Groundwater Application Review Summary Form

Application # G- 19400

A. GENERAL INFORMATION: Applicant's Name: Westridge HOA I County: Crook

A1. Applicant(s) seek(s) 0.245 cfs from 2 well(s) in the Deschutes Basin,
Lower Crooked subbasin

Water-Level Measurements in Nearby Wells

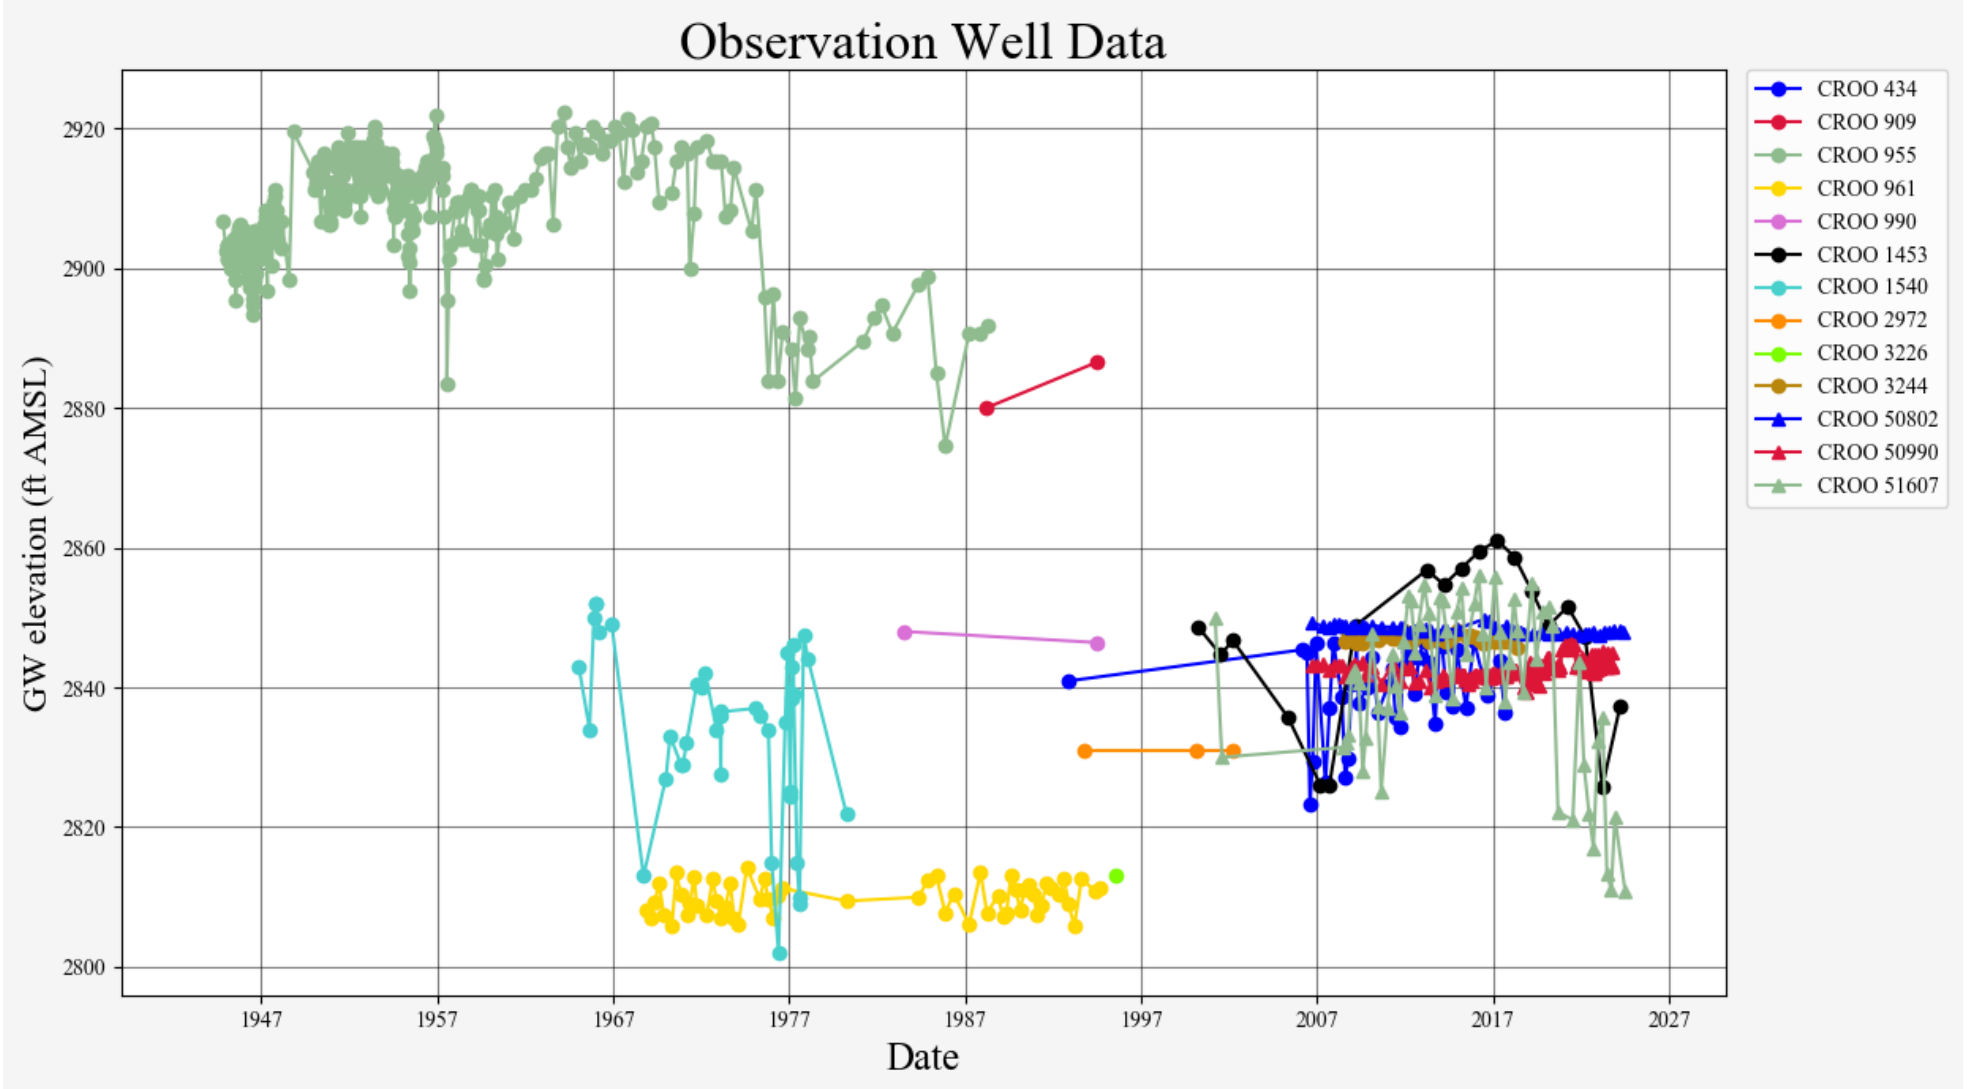
Water level data from adjacent observation wells indicates the presence of multiple distinct local groundwater flow systems within a five-mile radius including the deep alluvial aquifer in the Prineville Valley, the airport ASR sediment package, and shallow, recently deposited alluvium. The applicant's well appears to access an aquifer consisting of both volcanics and the overlying recent sediments with hydraulic connection with the adjacent Crooked River and irrigation ditch (see hydrograph 1). Considering the proximity, geologic formations encountered, and water level elevations, CROO 961 is likely the best representation of water levels at the applicant's well. CROO 961 shows 5-10 feet of seasonal fluctuation and no long-term declines from 1970-1995. Annual highs occur in mid-summer, likely due to canal leakage (see hydrograph 2). Because of the apparent influence of the adjacent surface water sources, it is unlikely that water levels have declined in the applicant's well despite not having recent water level data from CROO 3226 or CROO 961. The only available water level data for CROO 3226 is a driller's measurement from July 1995. The reference level shall be set after a permit is issued and water level measurements are submitted to satisfy permit conditions. The measurement date of March is chosen to measure the aquifer levels more accurately before pumping and canal leakage occurs.

- i. The permit should contain condition #(s) 7RLN (25 feet, period = March); Large WUR;
 - ii. The permit should be conditioned as indicated in item 2 below.
